SERVICE BULLETIN

Subject: Change to Water Shed used on 1/4 HP Gear Reducers

Water shed shown on 1/4 HP Gear Reducer

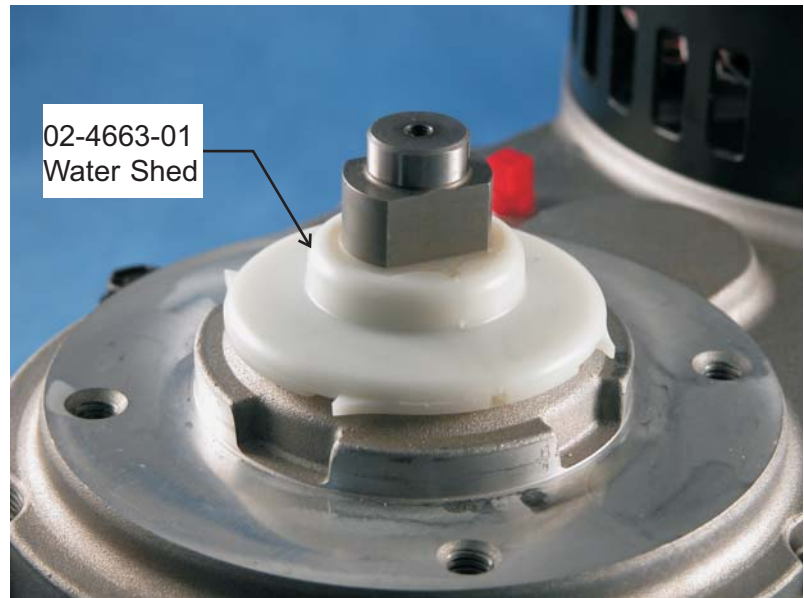
The water shed has had a design and part number change.

The new water shed, part number **02-4663-01**, replaces 13-0868-01, which is no longer available.

The water shed is positioned between the water seal and the gear reducer. Its function is to route condensation and/or leaking water away from the gear reducer output shaft.

The improvements include:

- Tighter fit to output shaft
- Firmer material, stays flat, does not round out
- Improved drip edge
- Sweep features to keep the drain path clear

All the above are intended to reduce water infiltration potential and improve gear reducer life.

Use began with units produced September 26, 2011.
